# DICK'S SPORTING GOODS HOUSE OF SPORT JSP24-31

# PLAN REVIEW CENTER REPORT Planning Review

Dick's Sporting Goods JSP24-31 March 14, 2025

Revised Preliminary Site Plan and Special Land Use

DRAWING NO.

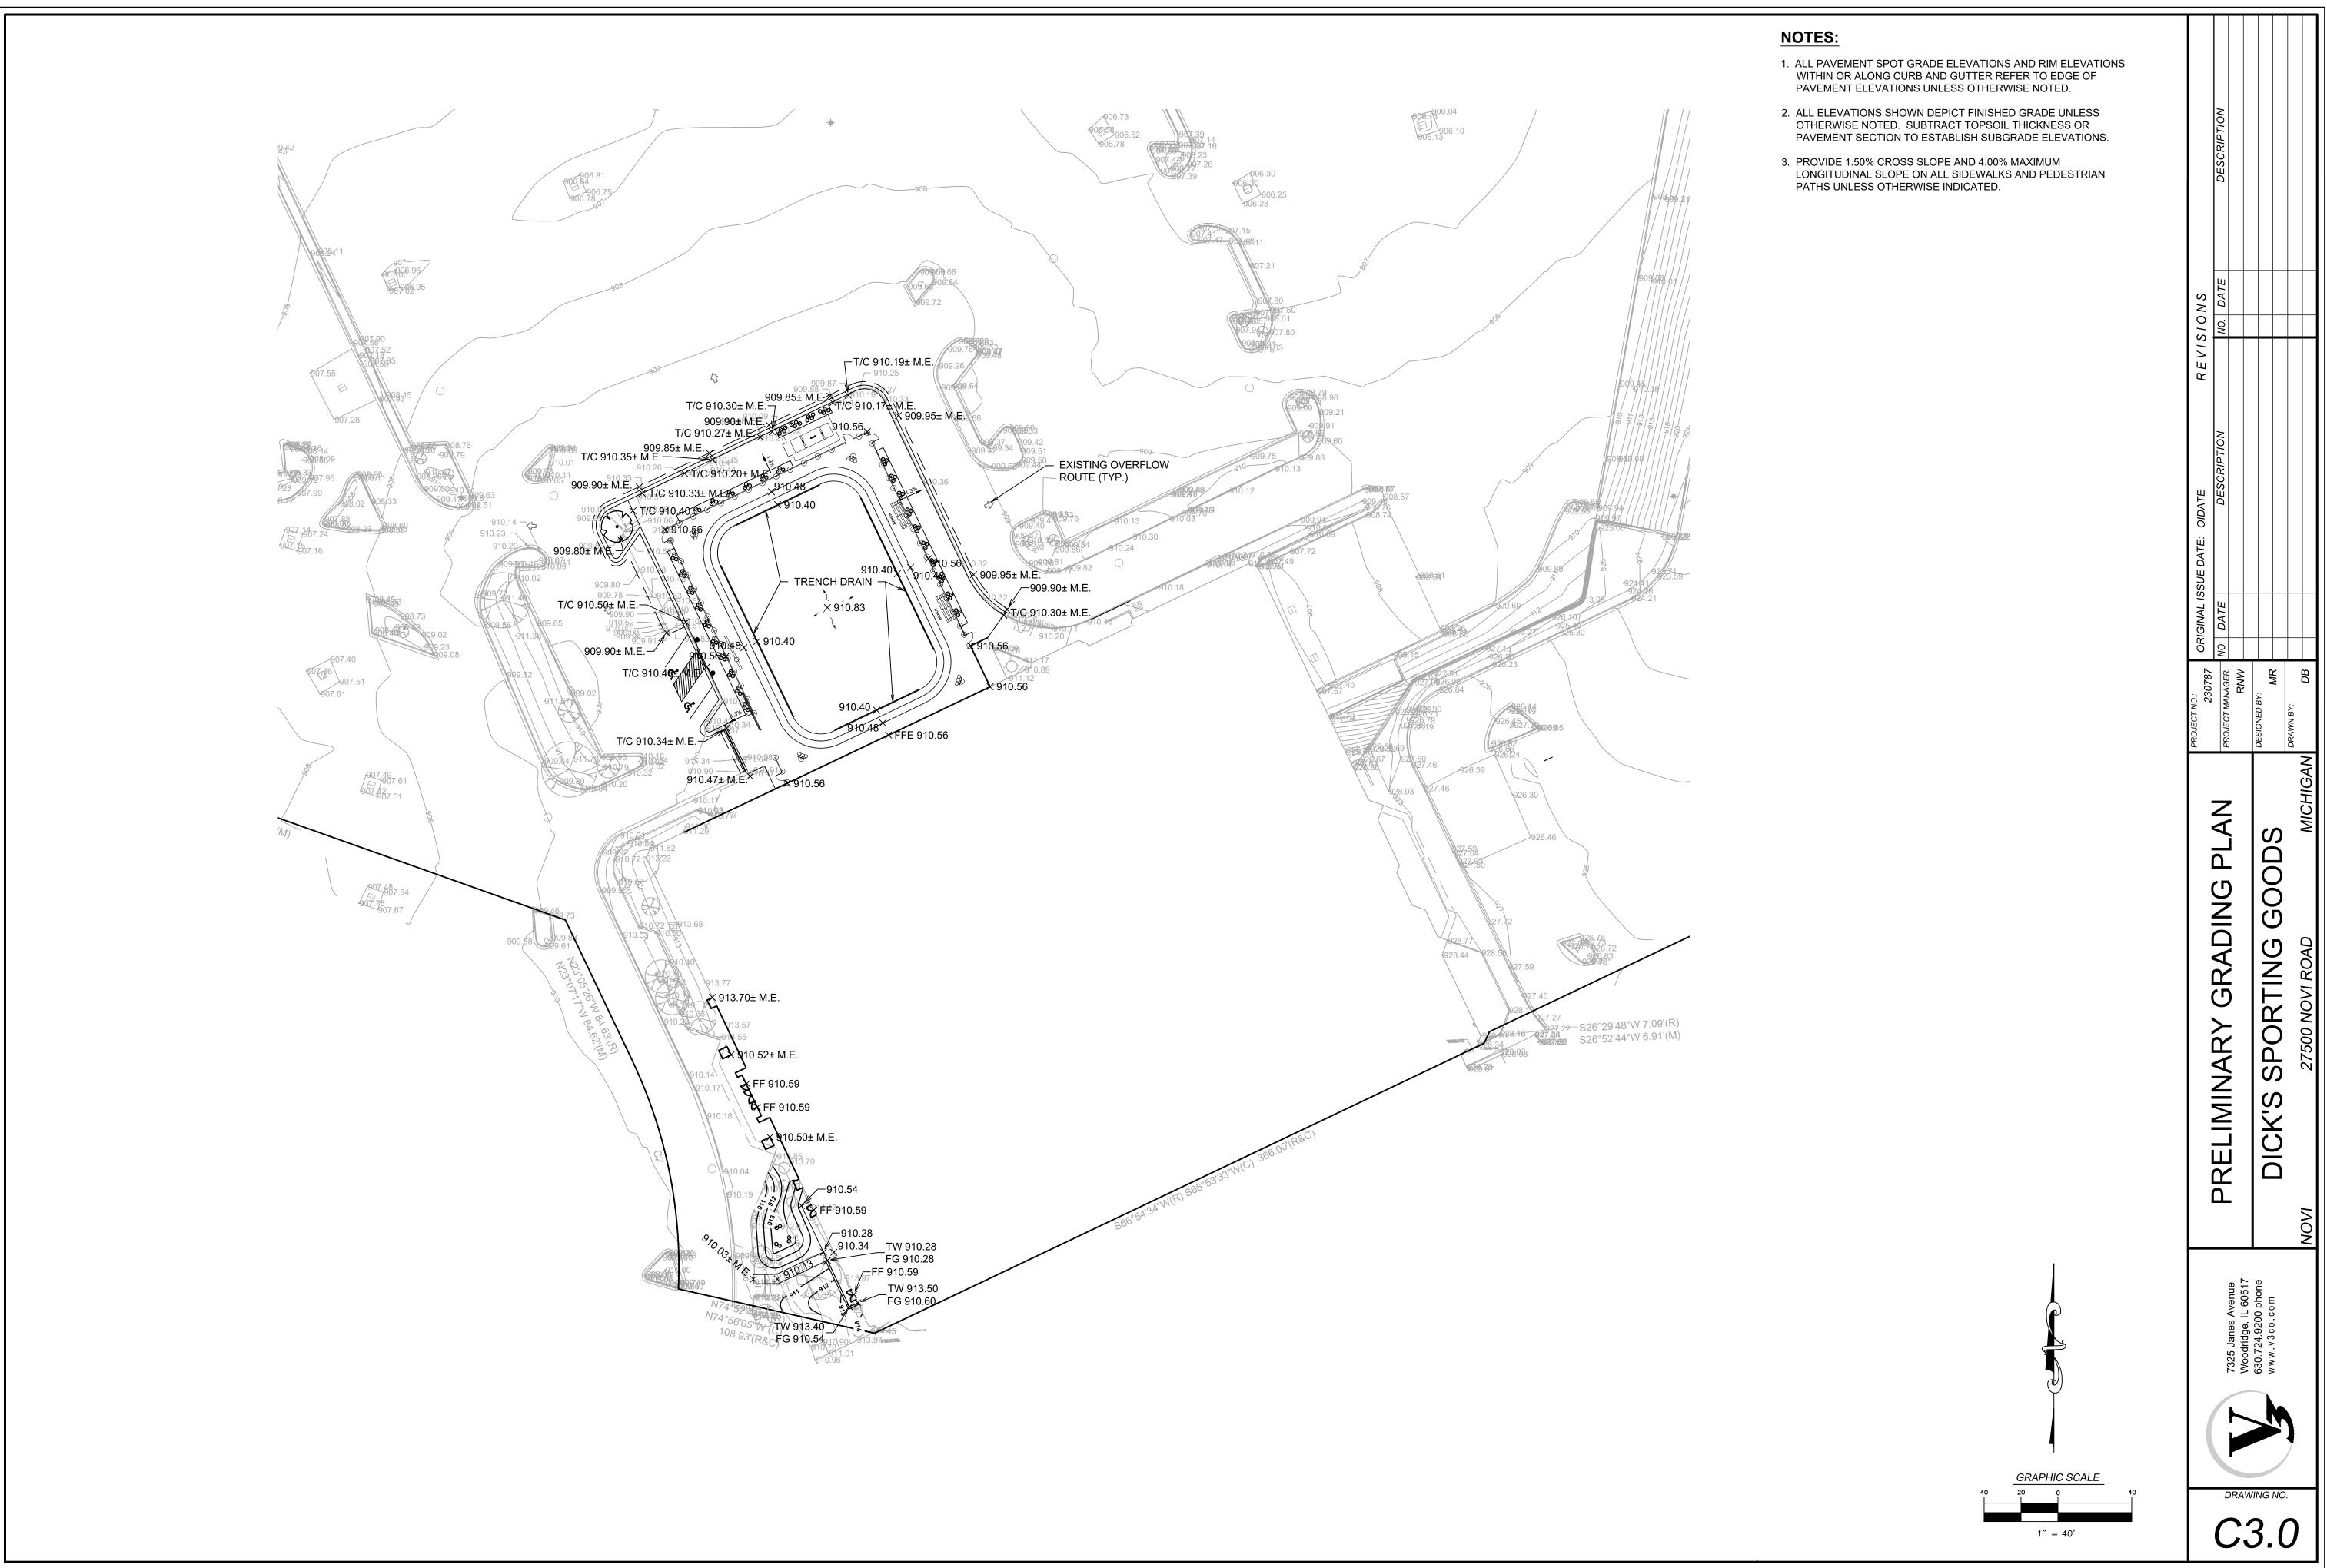
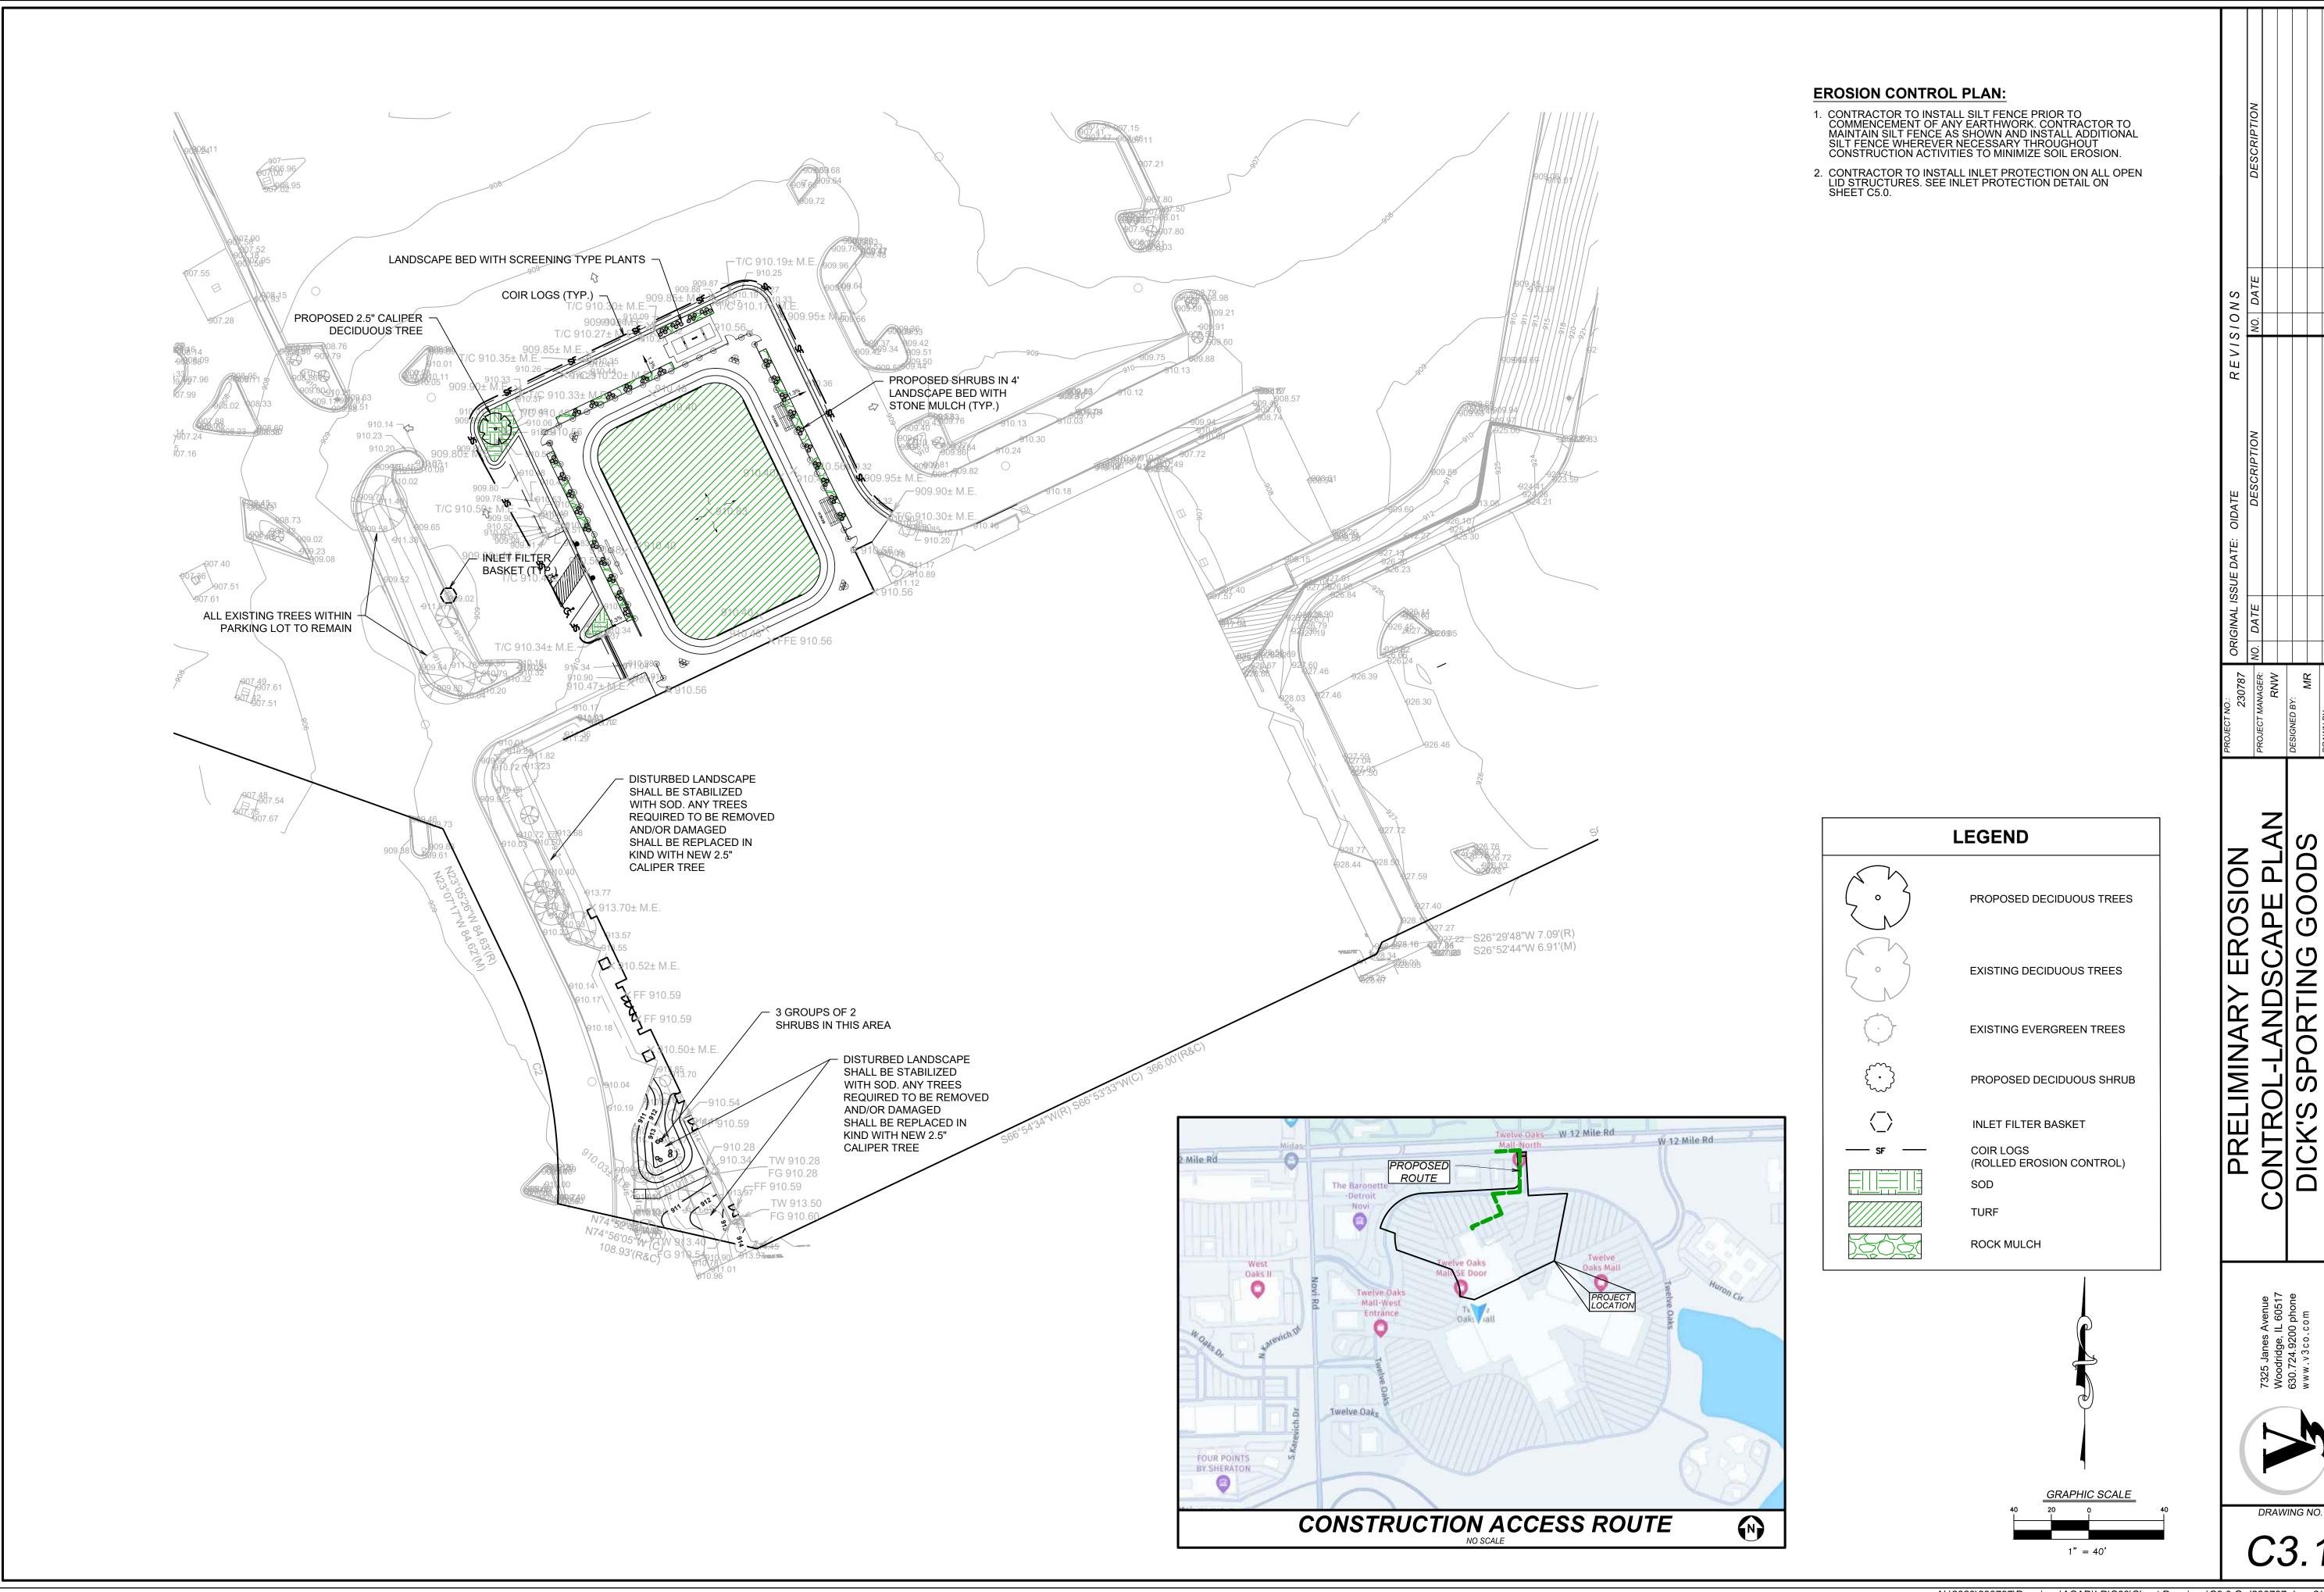
Comment 15: Sheet C4.0 indicates 18' light poles, lighting specifications and response letter indicate

Response:
